From: Koeppen, Joel <jkoeppen@kahlerslater.com>
Sent: Wednesday, May 14, 2025 3:05 PM
To: Bailey, Heather; 'Bruce Bosben'
Cc: Firchow, Kevin; Moskowitz, Jacob; Ochowicz, William; Bissen, Peter; Noelck, William; Sinnett, Joe
Subject: RE: Feedback on 124 E Gorham submittal to Landmarks Commission
Attachments: 25-0416_Landmarks Submittal_KS MARKUPS_Zoning + Permitting Comments.pdf

From: Bailey, Heather <HBailey@cityofmadison.com>
Sent: Thursday, May 1, 2025 2:28 PM
To: 'Bruce Bosben' <BBosben@apexrents.com>; Koeppen, Joel <jkoeppen@kahlerslater.com>
Cc: Firchow, Kevin <KFirchow@cityofmadison.com>; Moskowitz, Jacob <JMoskowitz@cityofmadison.com>; Ochowicz, William <district2@cityofmadison.com>
Subject: Feedback on 124 E Gorham submittal to Landmarks Commission

SITE PLAN

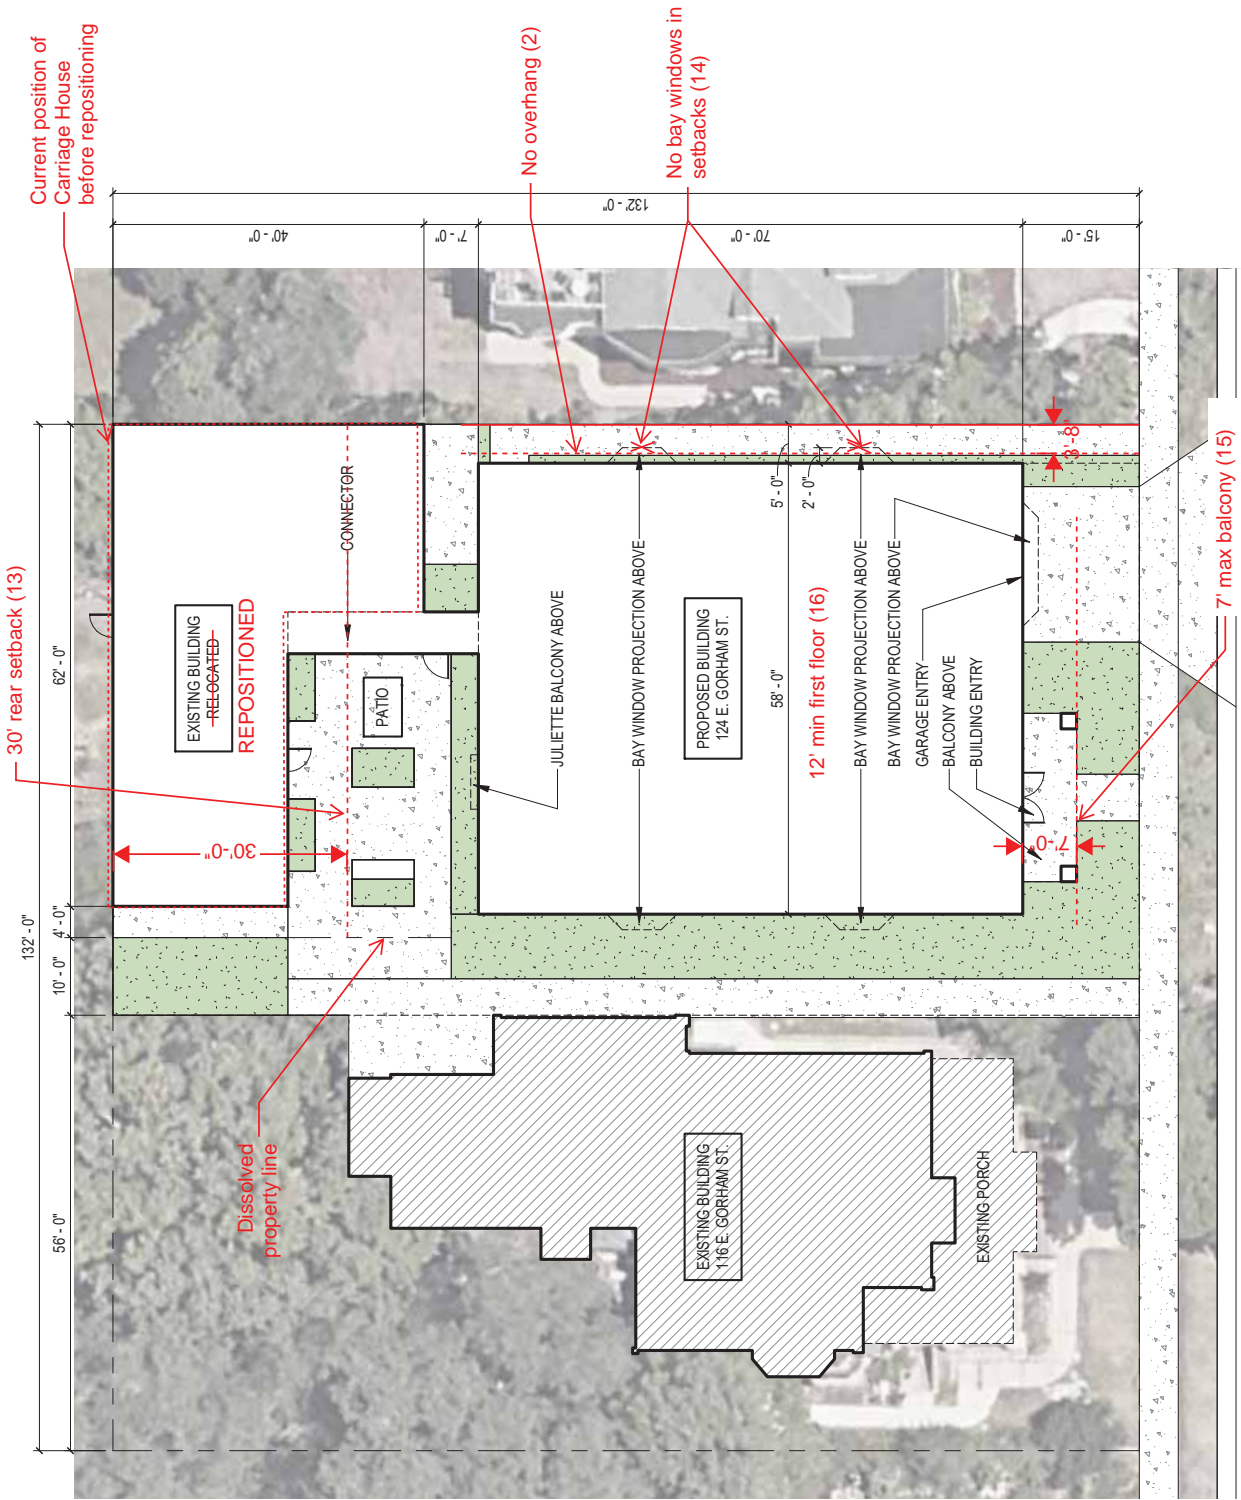
- 1) Per Fire Code, windows must be more than 3-feet from the property line. This is true for both the carriage house and the new structure. Your design does not meet that standard.
- 2) Per Building Code, building overhangs cannot be within 44-inches of the property line. The new structure's overhangs appear to not meet this standard and the relocated carriage house will not meet this standard as currently proposed with it resting on the lot line.

- 12) Because this project includes multiple residential buildings on one zoning lot, it is a residential building complex that requires conditional use and Urban Design Commission approval.
- 13) The proposed building does not comply with the required 30' rear yard setback in the DR1 zoning district. However, the Plan Commission can modify this setback requirement as part of the conditional use approval.
- 14) The bay window projections are not permitted in the required 5' side yard and 15' front yard. Only a one-story bay window meeting the definition in Sec. 28.211 is permitted.
- 15) The open porches shown on the front façade are permitted to encroach 7' into the required 15' front yard setback.
- 16) Per Sec. 28.071(3)(d), the minimum ground story height is 12 feet, measured from the sidewalk to the second story floor.

- We are right at 3'-0" on the east property boundary bay window projections (the only relevant location on the new construction, since the west property line is dissolving), but can reduce by a few inches for tolerance or we could just eliminate the bay windows altogether. The existing carriage house is being placed back where it is currently located, with a subtle shift to resolve the property line encroachment (inches) on the North – this subtle adjustment was a request from CoM made early on in our December 20th mtg. Since this triggers fire code issues, we need to evaluate our options for rated glass (expensive) or consider infilling existing openings (bad for units). Moving the carriage house inward on the site creates issues for access and pinches us even more on the site, but we will study the specific implications of this.

- The overhangs for new construction will comply. Could we consider a variance for the overhangs on the carriage house in this circumstance? We discussed this back in November and December mtgs (Heather, Matt, Kevin and Chris from CoM) and determined that the intent is that we would keep the existing carriage house in its original location, provided we resolved the lot line encroachment issue on the North and a no build easement could be pursued on the east and north. Out of curiosity, if we just left the carriage house as is in its existing location and not repositioned it, what would be the evaluation of this constraint in the case of a simple interior renovation?

- Our *new construction* complies with the 30' setback on the rear. The existing carriage house is on the lot line – is the comment that the carriage house doesn't comply? Are you considering the new construction and existing carriage house as one continuous development regardless of the connector and whether or not we reposition the existing building? If so, we would be interested in pursuing a modification at PC.

- We can eliminate the bay windows that do not comply. However, is there an opportunity for a variance on this?

- **Our current FTF height at the ground level is 11'-0", due to the grades onsite as we understand them. Raising another foot could be done, but creates are more difficult condition to resolve grades and accessible slopes onsite or pushes us further into the ground (accessibility at the street entry could be affected). We will look into this, but would there be an opportunity for a variance on this if it creates a hardship?**
